BROOKS RECYCLED WATER PUMP STATION UPGRADES PROJECT
Solicitation Number: CO-00657
Job No.: 21-8601

ADDENDUM 2
September 27, 2023

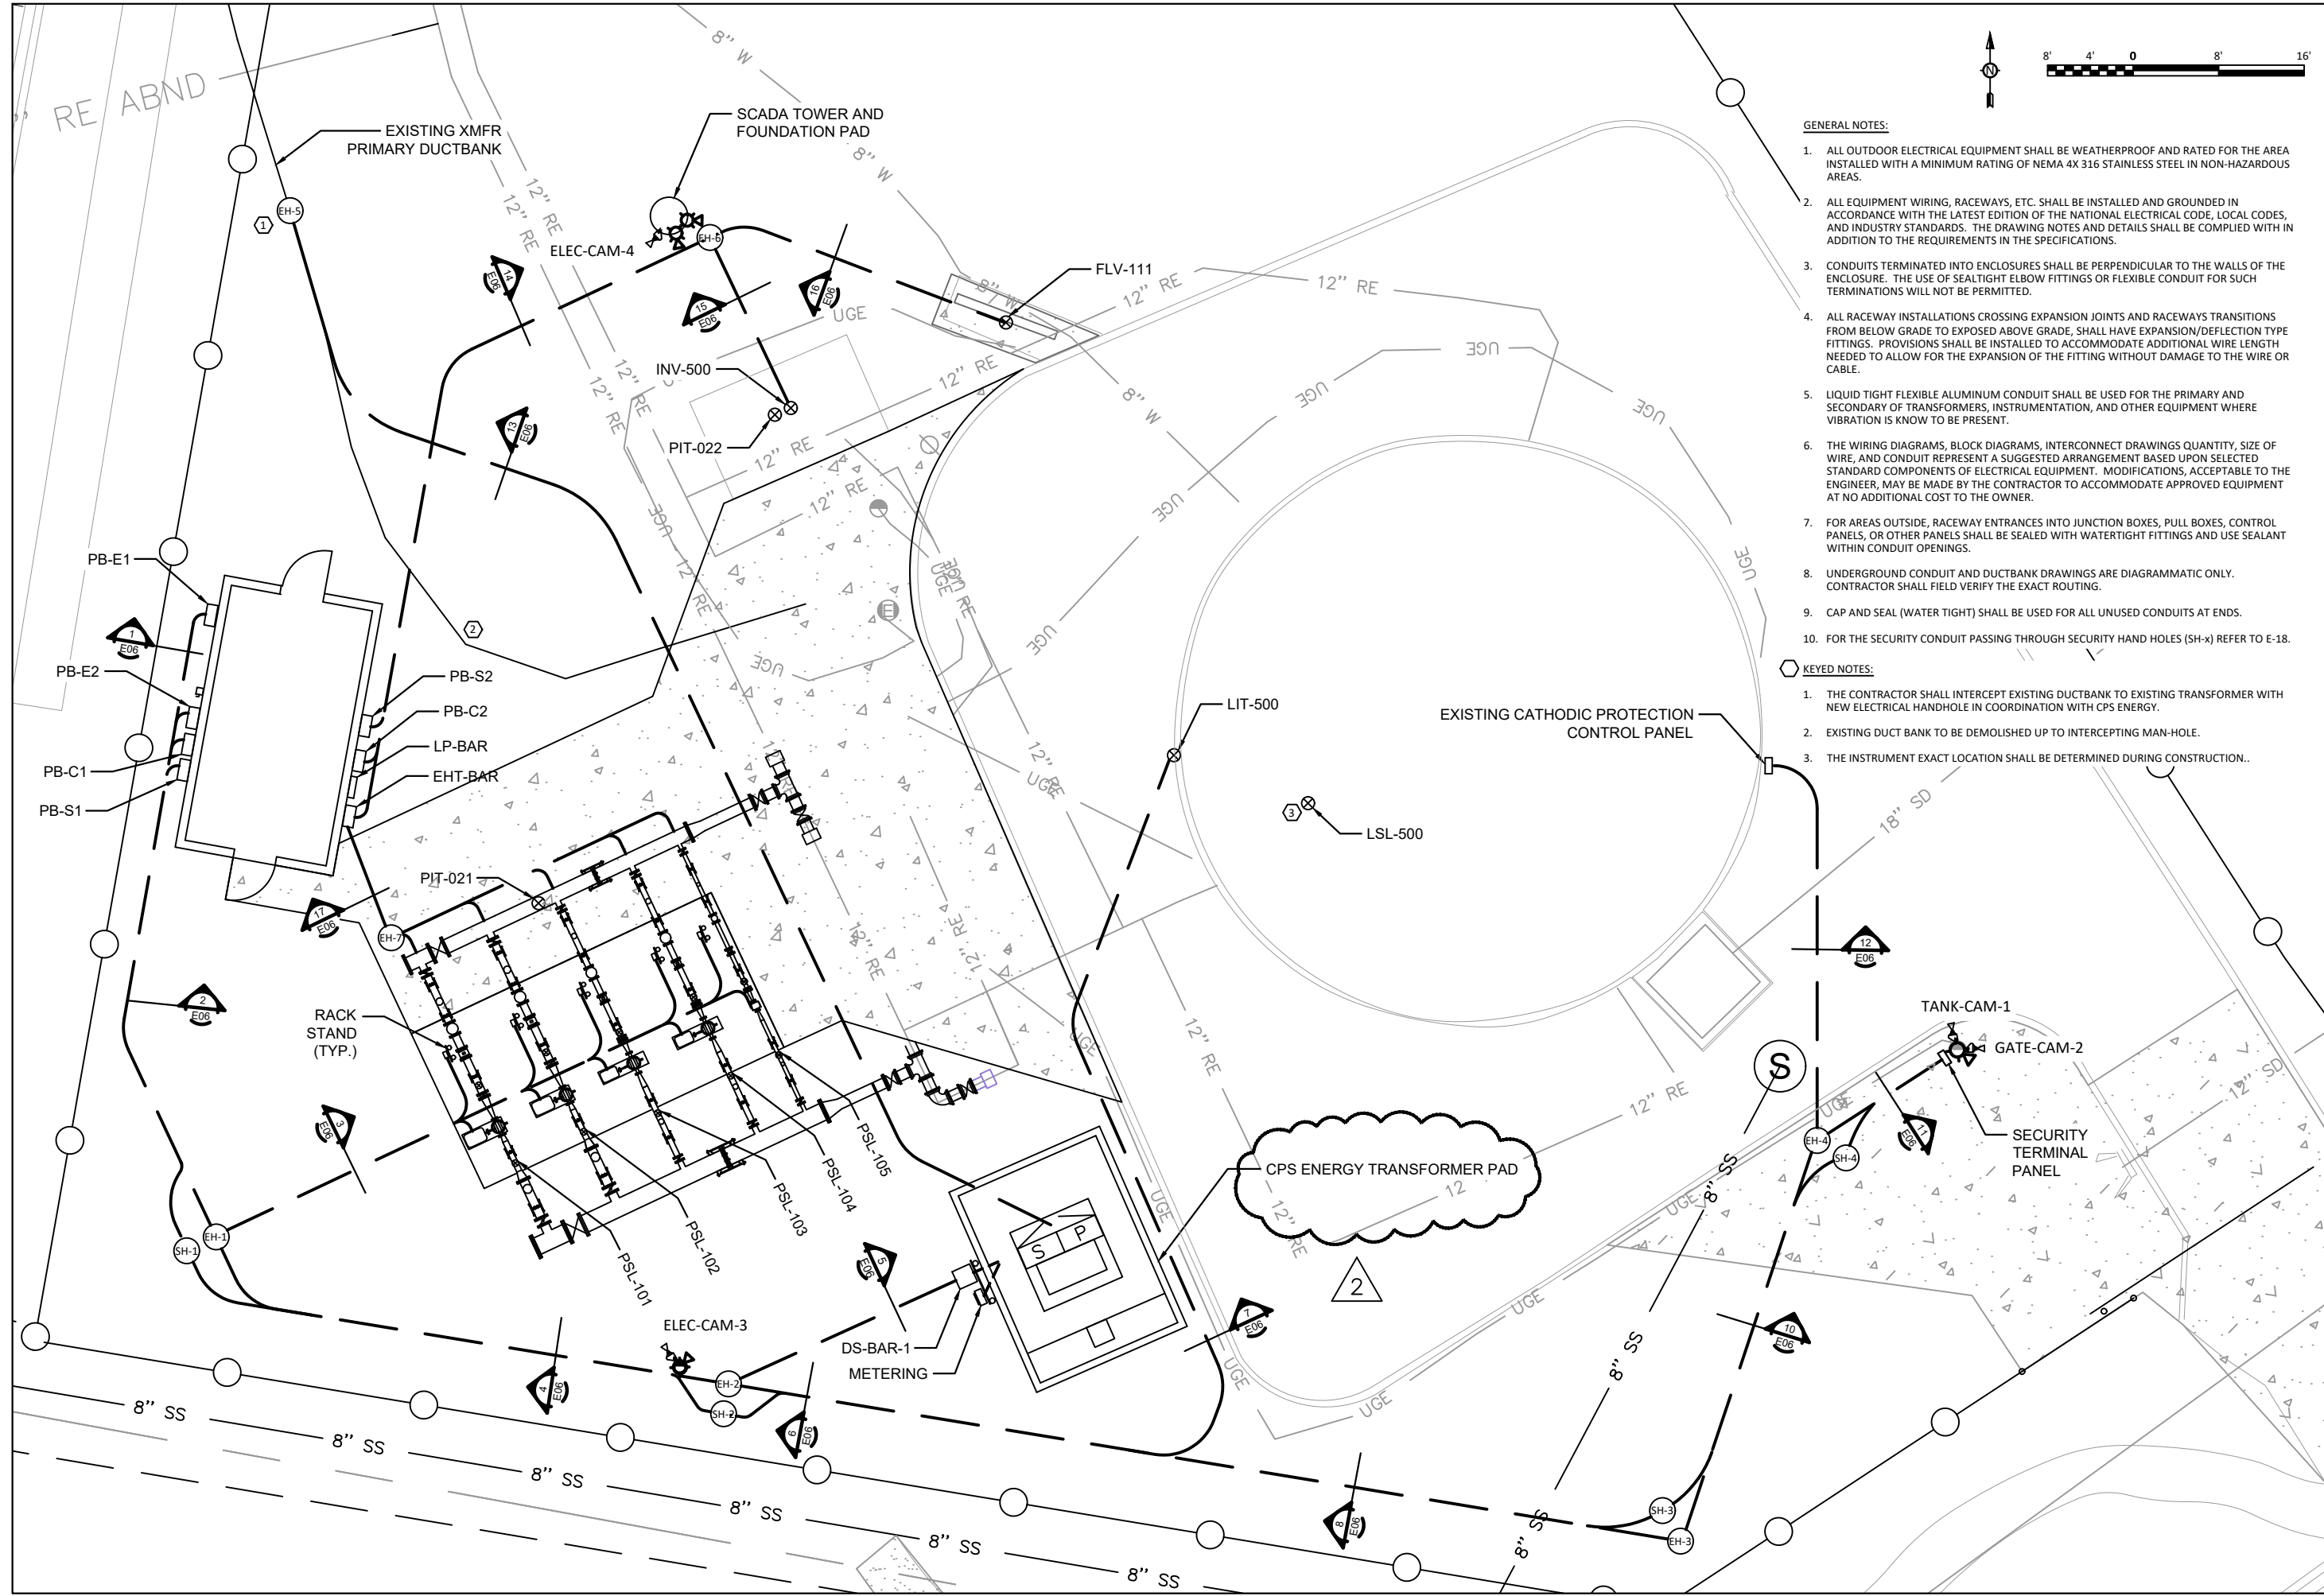
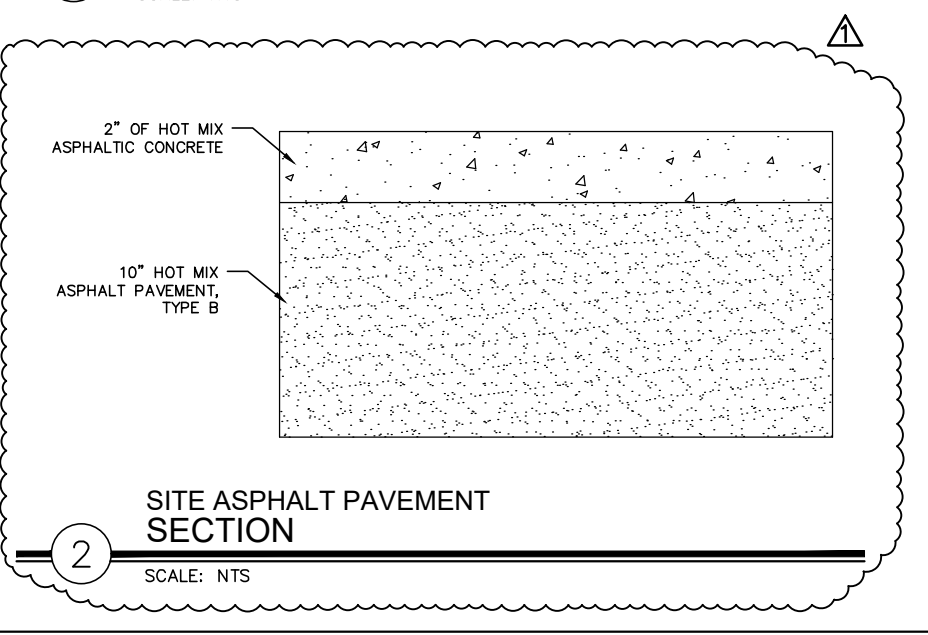
- 15. Question: There is a lot of asphalt replacement but no asphalt section details to go off of (ex. A stone layer, tie in, etc.) Please provide details for the asphalt.**

Response: Clarification has been added to Sheets C3 and C12 regarding asphalt replacement and the existing pavement section. Please refer to Changes to the Plans Nos. 3 and 5 of this Addendum.

2 SITE ASPHALT PAVEMENT SECTION
 SCALE: NTS

DRAWING NO.
E-06

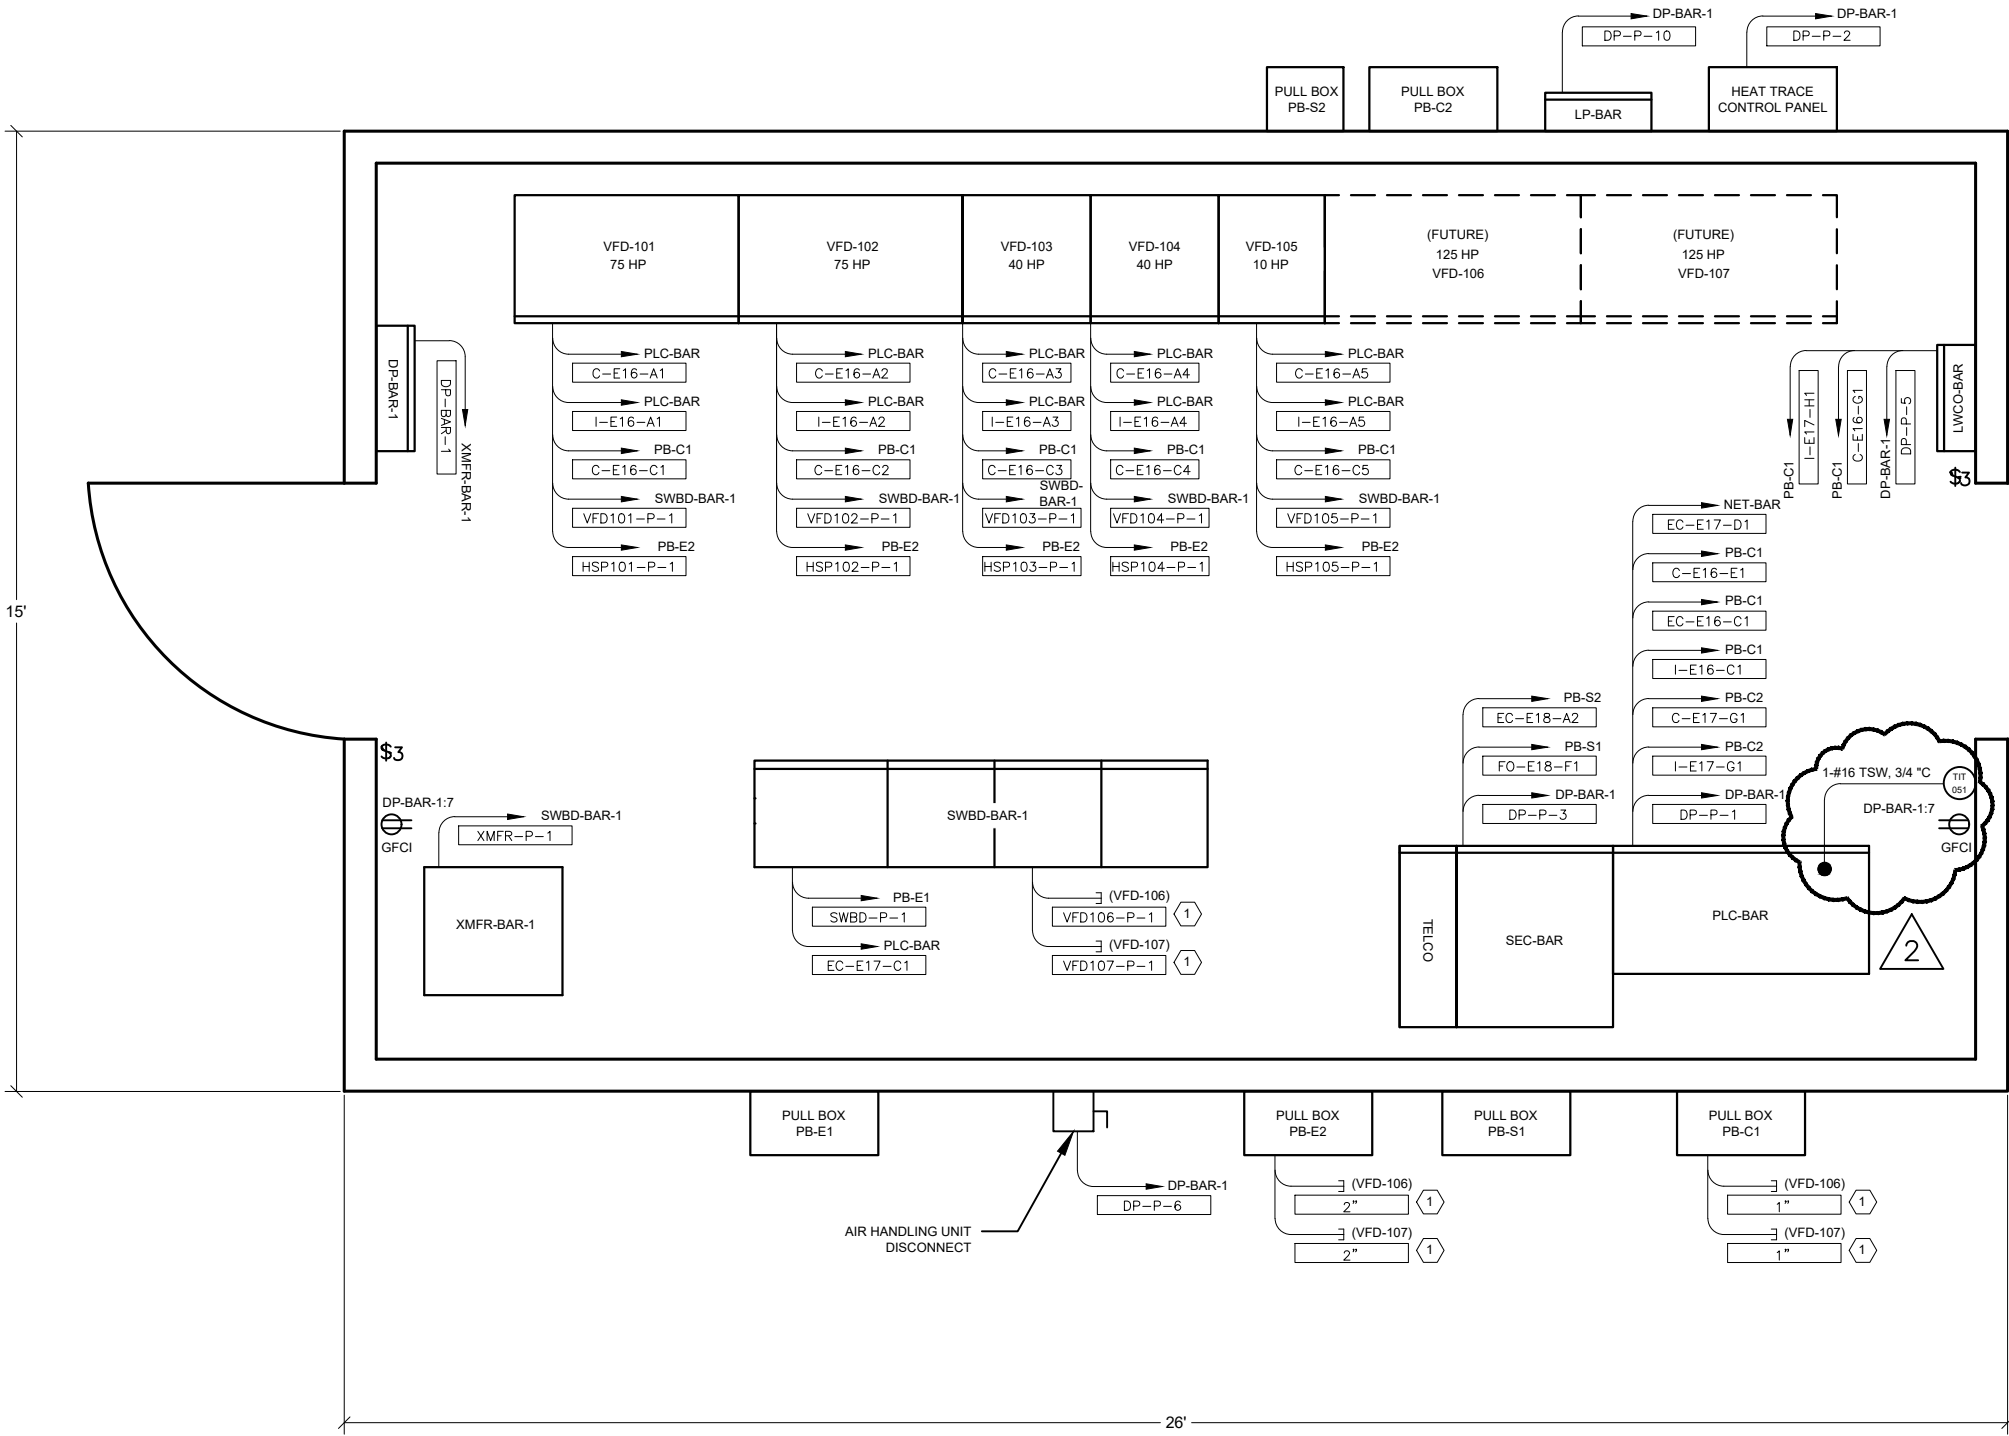
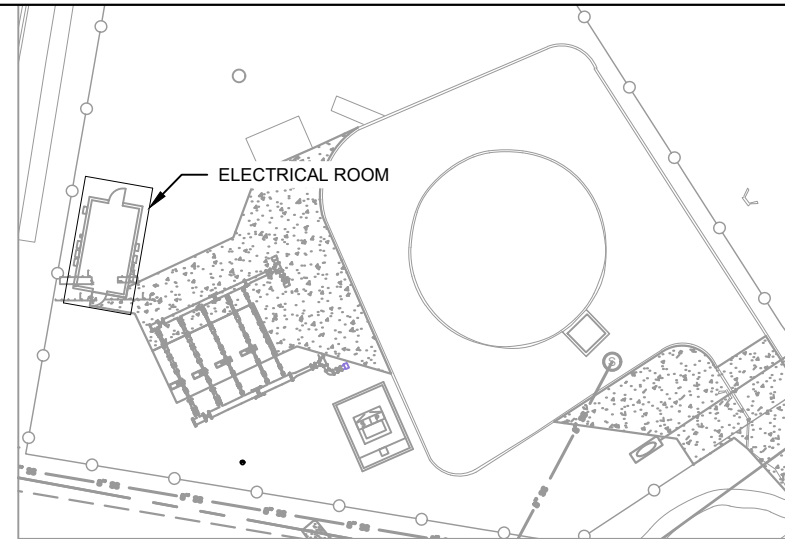
- 16. Question: There are discrepancies between 1-line diagram E08, SWBD-P-2 showing 4 - (3) 500KCMIL + #1/0 AWG (GND), 3" C and ductbank section 5, 4, 2 & 1 on E06 showing to have (2) 4" conduit with (2) 4" spares. Please review and revise.**

Response: Sheet E-08 cable/conduit description has been changed to a 4-inch conduit. Ductbank sections 1, 2, 4, & 5 will replace the SPARE 4-inch conduits to read SWBD1-P-2C and SWBD-P-2D. Please refer to Changes to the Plans No. 9 of this Addendum.
